P5022A-03-S

Safety Service Note

P5022A Keysight Streamline USB Vector Network Analyzer

“POTENTIAL BURN INJURY (HIGH TEMPERATURE) HAZARD”

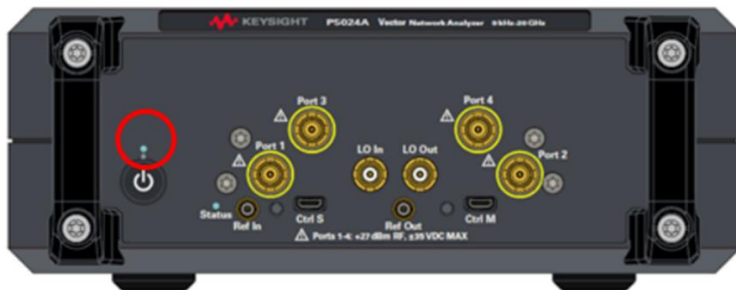
Symptom:

VNA fails to start with the following symptoms.

1. LED indicator (below circle) turns red.
2. cooling fan does not work
3. If user leaves the VNA with this LED indicator red without turning off power switch, it continues to overheat and becomes too hot.

Solution-1: Update VNA firmware by user

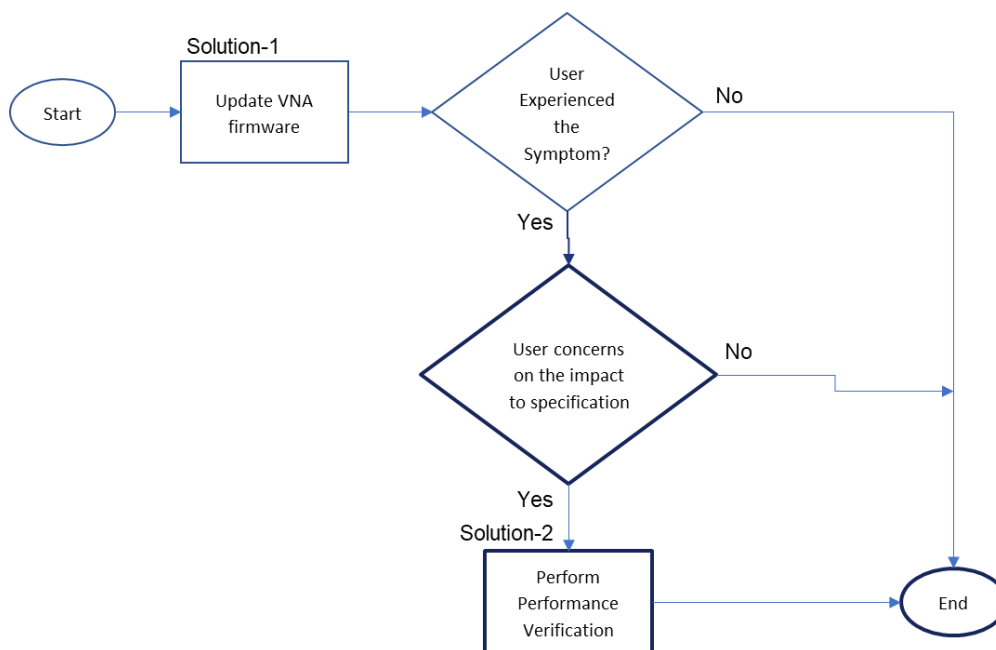
Potential presence of high temperature on front panel & chassis.
Earlier versions of firmware have potential risk of overheating, due to thermal fan control malfunction.
As a result, user may experience first degree epidermis burns on hand/ finger if in contact with the front panel & chassis.

Action-1: Updating the firmware eliminates this potential risk of overheating.

1. **Install the latest VNA firmware Rev. A.15.40.13 or newer on users' controller PC(s).**
The latest firmware enhanced the thermal fan control mechanism.
2. Once the latest firmware is installed, proceed with the restart of both **controller PC** and **VNA**.
3. Launch the VNA firmware. Ensure VNA powers up and launches into firmware correctly after firmware update is done.
